Table D 3.1.1-1 (Page 1 of 2)
Radioactive Liquid Waste Sampling and Analysis

In the relocation and conversion of the Nine Mile Point Unit 2 current Technical Specifications (CTS) to the proposed Offsite Dose Calculation Manual (ODCM) used in support of the Improved Technical Specifications (ITS), certain wording preferences or conventions are adopted that do not result in technical changes (either actual or interpretational). Editorial changes, the elimination of redundant wording, reformatting and revised numbering are adopted to make the ODCM consistent with ITS.

FIGURE 4.1-1
SITE BOUNDARIES

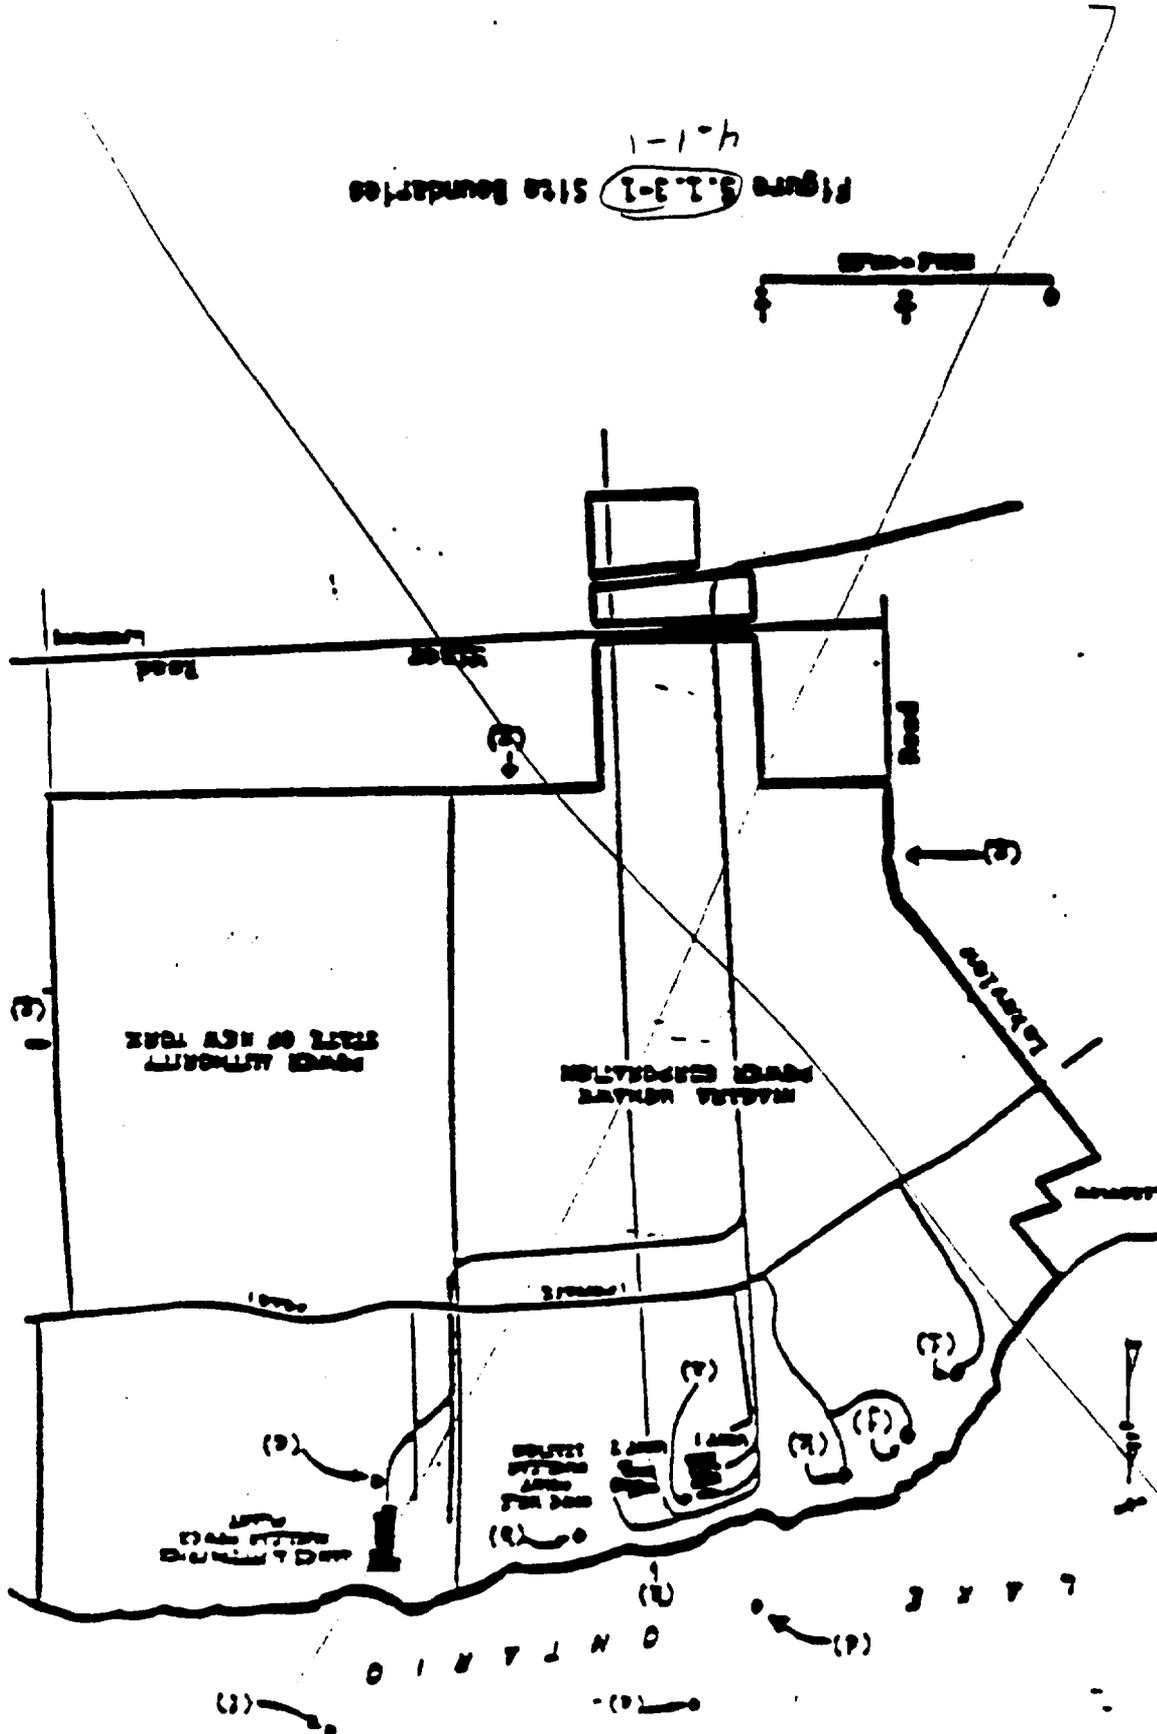
In the specific case of the Design Features, the section has been deleted. The map has been relocated to D 1.0, Definitions, as Figure D 1.0-1.

4.1 The site area boundary and the land portion of the exclusion area boundary are as shown in Figure 4.1-1. The lake portion of the exclusion area boundary is the area of Lake Ontario within a 2 mile radius of the Nine Mile Point Unit 2 Reactor centerline.

Figure 4.1-1 (Page 1 of 1)
Site Area and Land Portion of Exclusion Area Boundaries

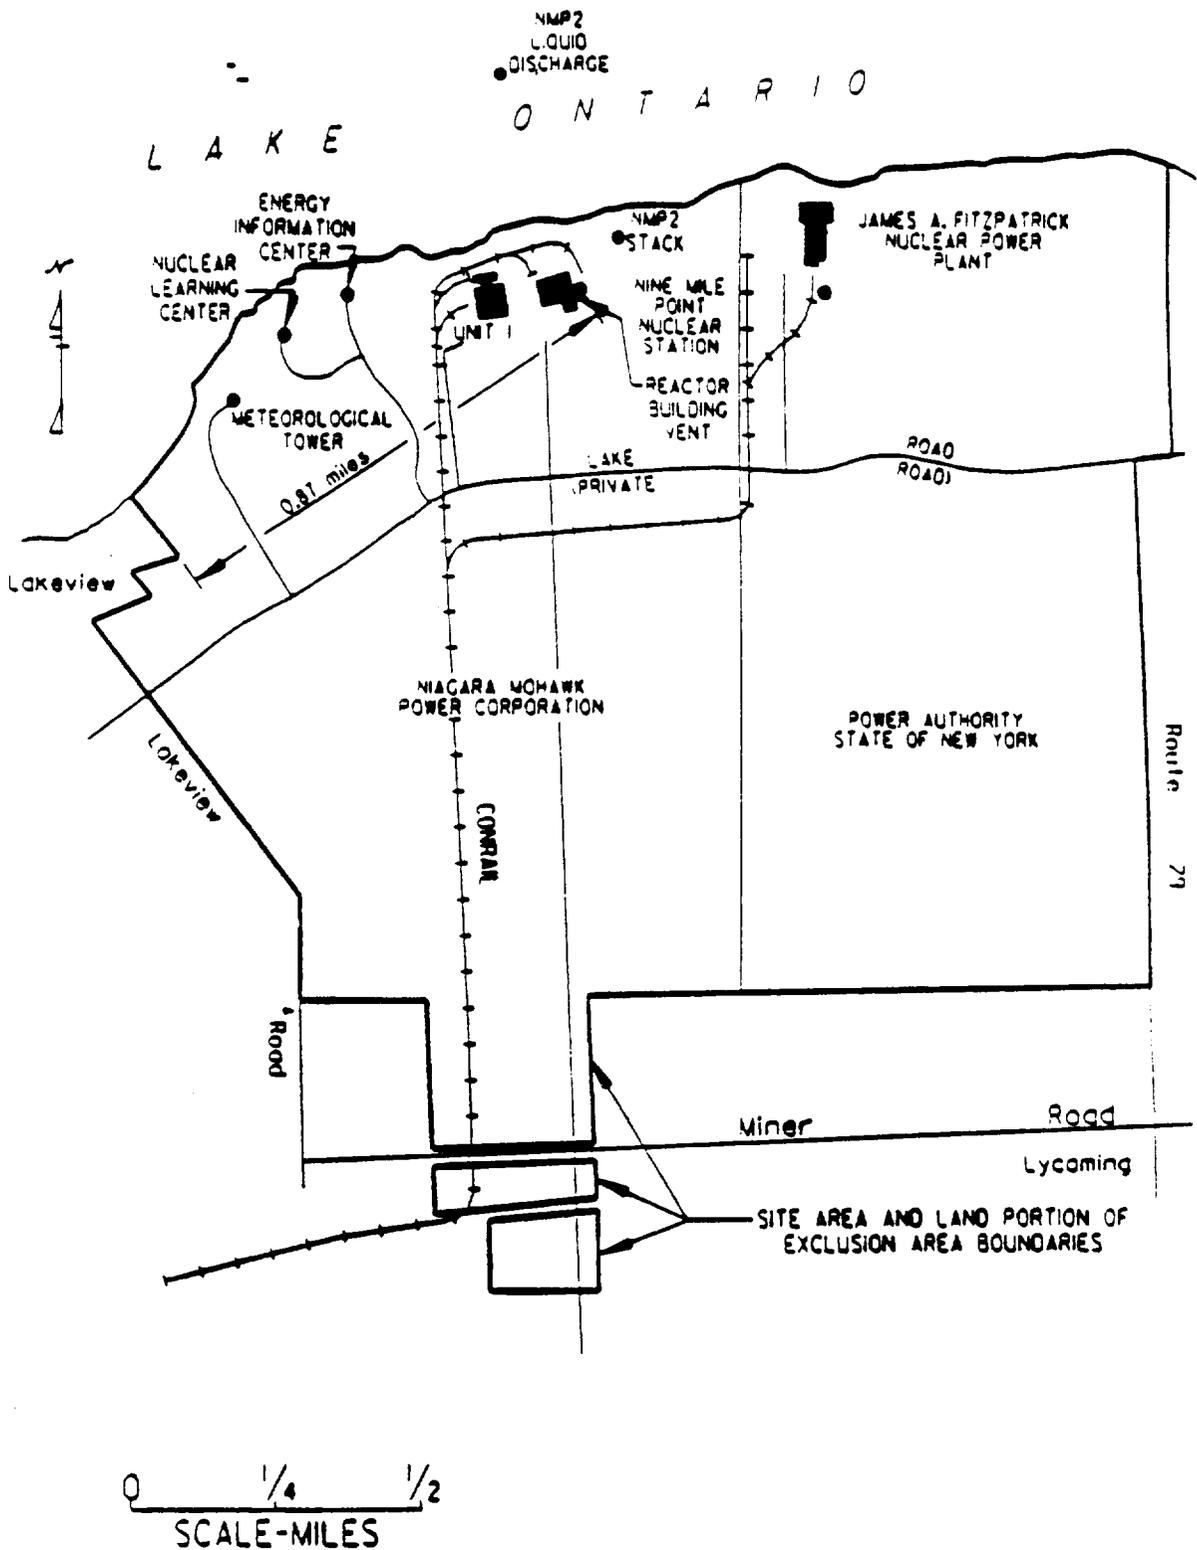
The site area boundary and the land portion of the exclusion area boundary are as shown in Figure 4.1-1. The lake portion of the exclusion area boundary is the area of Lake Ontario within a 2 mile radius of the Nine Mile Point Unit 2 reactor centerline.

Figure 4.1-1 (Page 1 of 1)
Site Area and Land Portion of Exclusion Area Boundaries

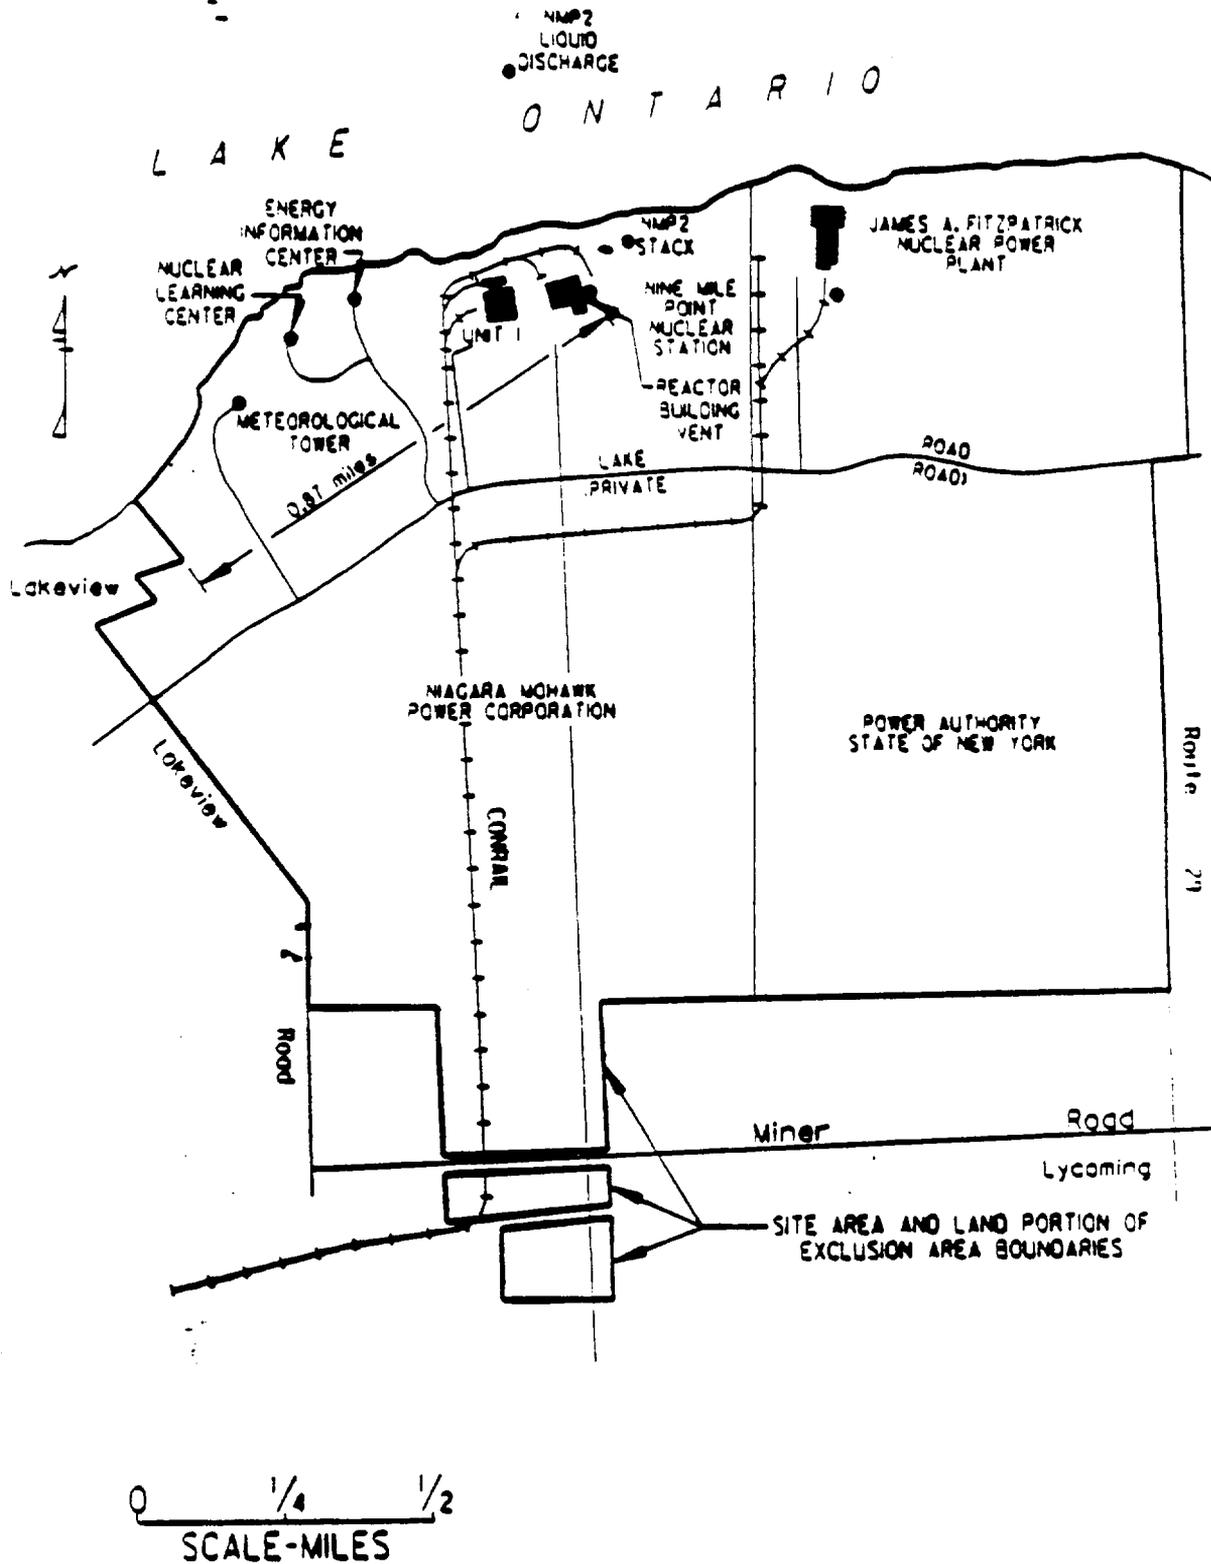
as shown in Figure 4.1-1
